Supporting Content for Comment 317 SCMR Limit Adjustment

Week of September 15th

Table 179-14—Cable assembly characteristics summary

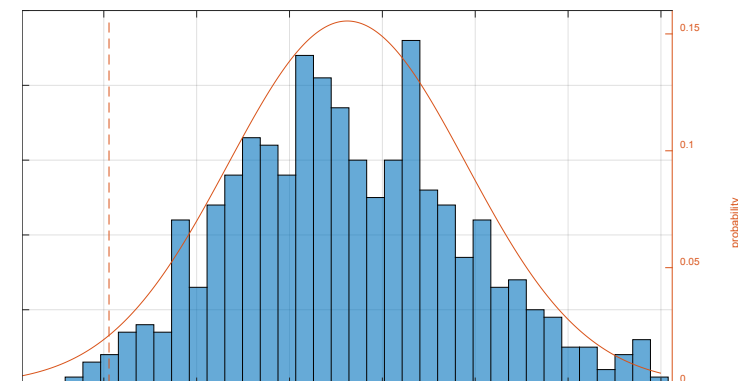
- **SCMR**, a new normative parameter 200GBASE-CR1, 400GBASE-CR2, and 800GBASE-CR4 devices, was introduced in D2.1.
- SCMR was extracted from 624 differential pairs from 39 cable assemblies. The total distribution of all SCMR metrics from all cables is shown to the right.
- This data is from cables that are operating successfully in the field.
- **Proposal:** change the minimum $SCMR_{CH}$ from 20 dB to 11 dB
 - Reduces the failure rate of successfully operating production level components from 96.3% to 3.7%.

| Description | Reference | Value | Unit |
|---|-----------|---|------|
| Channel signal to common-mode ratio, $SCMR_{CH}$ (min) | 179.11.8 | 20 | dB |
